**Land 800 metres South of Park House Farm, Meriden Road,
Fillongley, North Warwickshire**

**Sam Oxley CMLI on behalf of North
Warwickshire Borough Council**
**Landscape and Visual Effects, and
Consideration of Green Belt**

Final report

APP/R3705/W/24/3349391 (PAP/2023/0071)

Figure 2.1 Topography Plan [FPCR Figure 5]

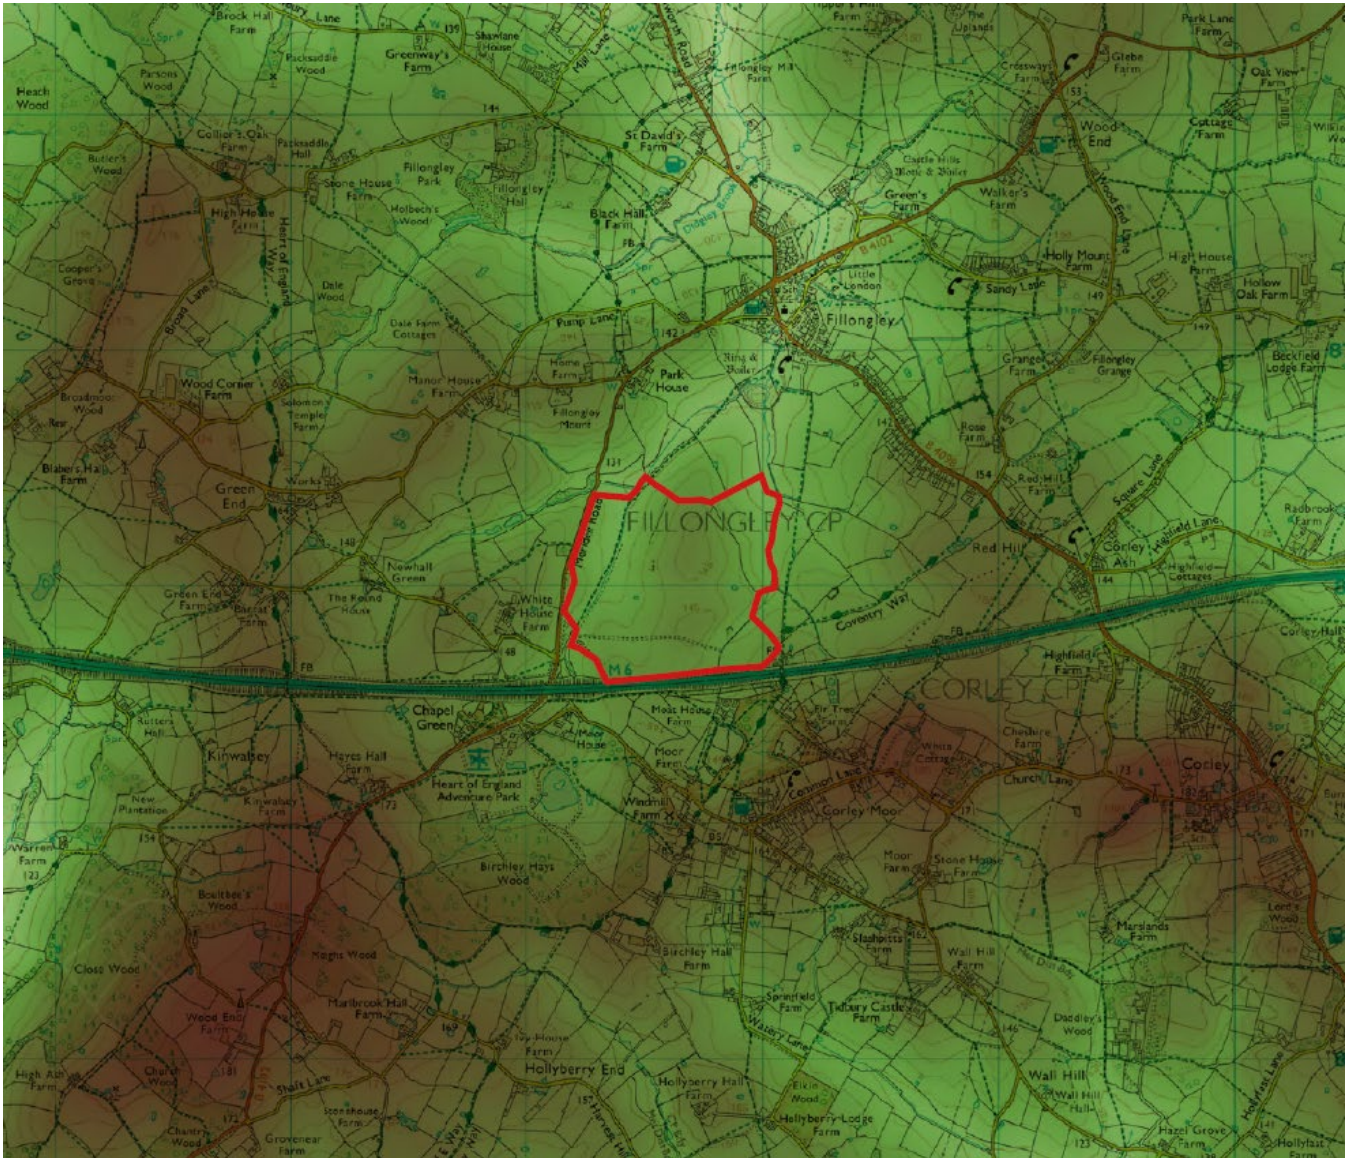
- 2.11 The appellant has provided a topographical plan which assists in understanding the landform of the site and surrounding landscape [Figure 5 in NW-02]. The darker brown areas indicate the higher land around the wider landscape of the site, which will provide a limit to the zone of theoretical visibility (ZTV).

Figure 3.2 Viewpoint location plan [extract from SLR Drawing P24-1827_EN_10]

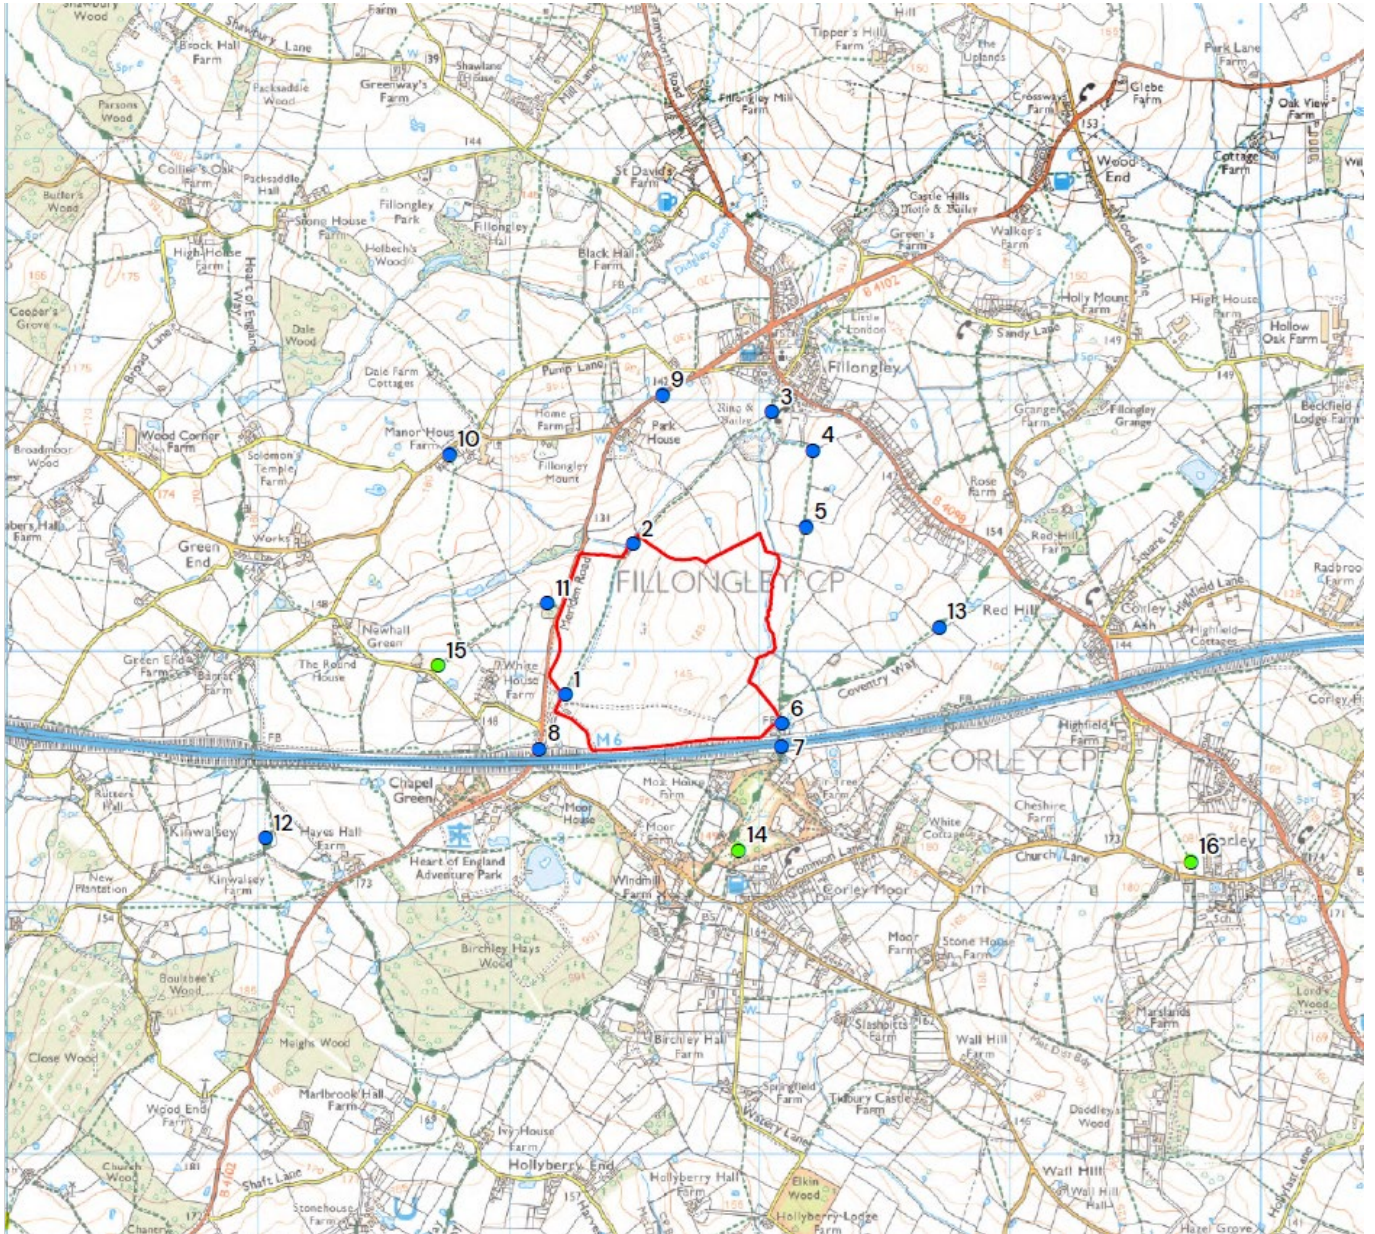
3.53 It is my opinion that the sensitivities of receptors that are given appear to be appropriate, however, the magnitude of change identified for many viewpoints (at construction, upon completion and after 15 years) seemed to be understated, with most viewpoints identified as having a medium/low/negligible magnitude of change.

3.55 As an example of apparent under assessment, the appellant identifies adverse effects from **Park House farm** but notes these as being **Moderate/Minor** at all stages, with the magnitude of change being medium/low through to low. The appellant states that it is difficult to make out the site from the farm, but my experience of this in the field was that there are clear views across to the site from this location, especially as there is no hedgerow along the road. The open field to the north east of the farm is bound by park railings and enables a very clear view of the site, seen just across the valley. Essentially, all of the ploughed fields across the full extent of the view photographed below will become solar panels. An extract from the photomontage prepared for VP9 assists in understanding the extent of the change, but as with all the photomontages which are provided, it is a very small image, showing approximately 80 degree view, which essentially

Figure 3.7 Extract from Design Statement, Figure 5.4 Proposed perimeter fencing, page 11 NW-05.

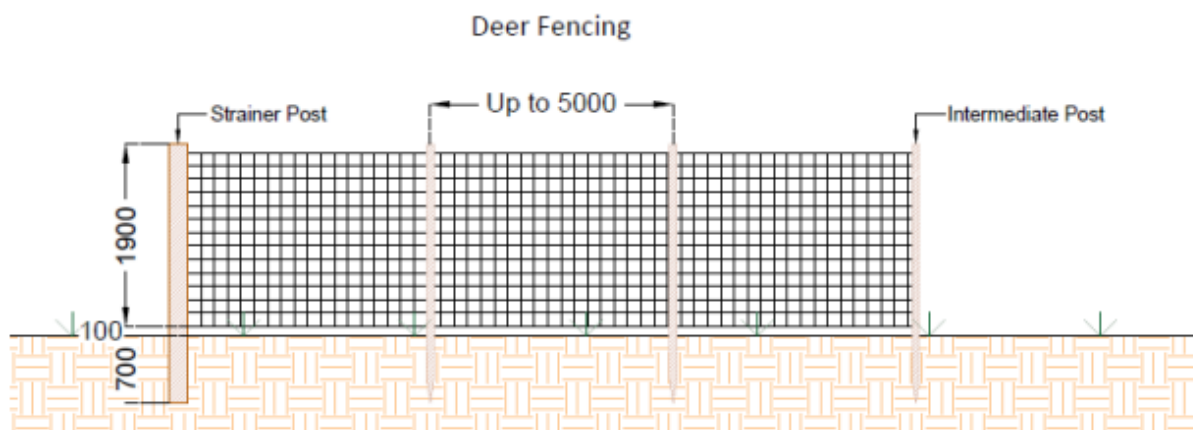
- 3.58 The appellant's LVA [NW-02] does not appear to consider the effects of security fencing and gates. Some further information is given in the appellant's SoC [NW-03].
- 3.59 2m perimeter fencing would be steel wire, which would enclose the site on all sides. Whilst labelled as deer fencing, its purpose is one of site security, and it will be used extensively. It will alter the character of the landscape and the visual amenity of those passing alongside it, especially via PRoW, making the landscape feel less open and rural.

Figure 3.8 Approximate Visual Envelope [Figure 6 of the LVA] aligned with bare earth ZTV below at a similar scale

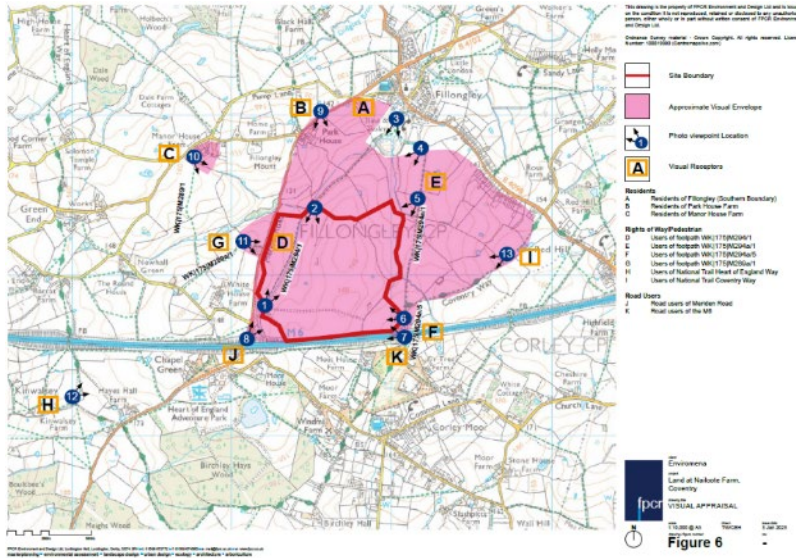
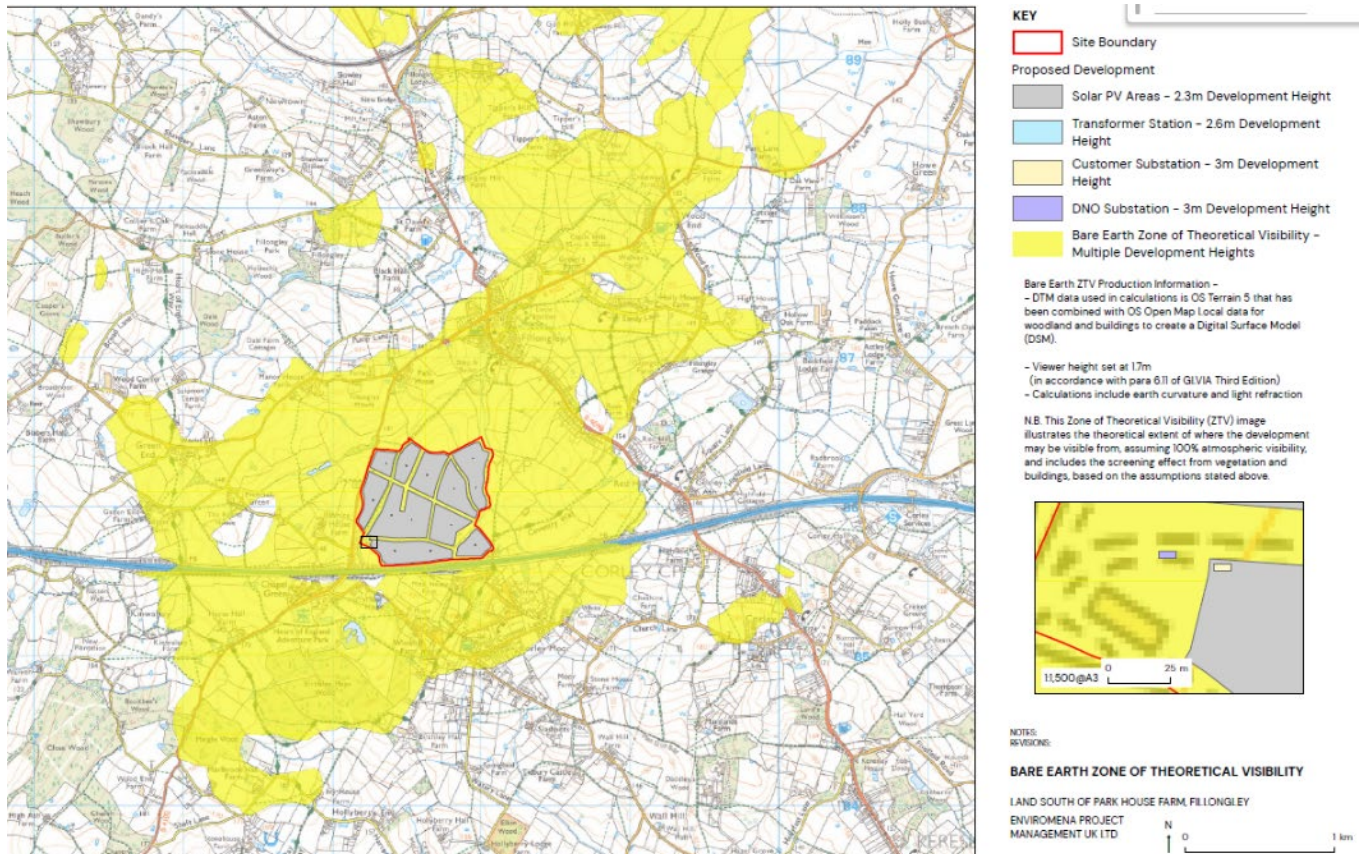
- 3.61 The appellant provided a hand drawn Approximate Visual Envelope (Figure 6 of the LVA) as part of the original LVA [NW-02].
- 3.62 This provides an approximation of the extent of visibility but in places the approximation is incorrect. In particular it is wrong in that the visibility from the west is not captured. There are clear views from Green End Road and the area of Home Farm, Fillongley Mount, and further south from the area around White House Farm. There are longer distance views from the north for example around Tipper's Hill Farm. There are also views from the south despite the woodland along the M6. When standing on the site properties to the south of the M6 can be seen, which in turn means there will be views available from these properties – this is the area around Corely Moor, Kinwalsey, Hayes Hall Farm, Windmill Farm.

- 3.63 A new Bare Earth ZTV (Figure P24-1827-EN-09, [NW-03] Appendix 9) was provided by the appellant in October 2024. As would be expected, this ZTV closely mirrors the topography (see topography on Figure 5 of the original LVA), and extends out to the enclosing ridgelines to the west, south east and north.

- 3.65 The new ZTV provides a more accurate representation of the extent of theoretical visibility. I can confirm through site visits that the wider area now shown will frequently have visibility of the proposed development, particularly in the years whilst mitigation planting is maturing. Areas where there is dense woodland (shaded green), and the built-up area of Fillongley would not enable visibility. In addition, hedgerows would locally filter views.

- 5.17** This, together with the recent provision of a more accurate ZTV, which appears quite different from the original, makes me question the robustness of the LVA.
